# City of Seattle

DESIGN  
REVIEW

## RECOMMENDATION OF THE EAST DESIGN REVIEW BOARD

Project Number: 3022596, 3020898, & 3023474

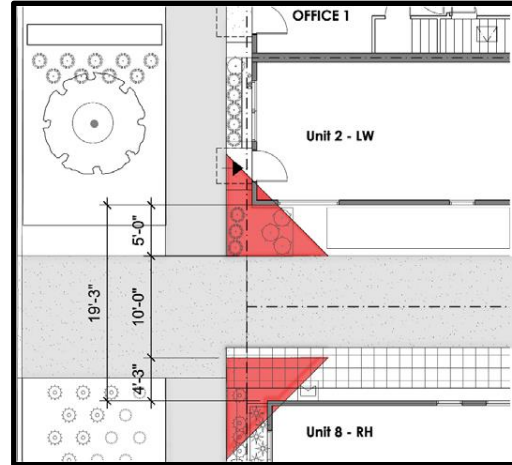
2. **Sight Triangle (SMC 23.54.030.G.1):** The Code requires a sight triangle be provided on both sides of the driveway be kept clear of any obstruction for a distance of 10 feet from the intersection as shown in red on the right.

The applicant proposes to encroach into both sides of the sight triangle by 1.5' on unit 8 and 3' for Unit 2 and the trash enclosure.

The Board unanimously approved the departure as strict application of the code would require one of the live/work and rowhouse units to be setback further than the existing commercial building to the north. This would reduce the continuous rowhouse appearance the Board wanted to see for 20<sup>th</sup> Street allowing for interaction opportunities for residents of the rowhomes, businesses in the live/work units, and neighbors, the intent of Design Guideline PL3-B-4 Residential Edges - Interaction.
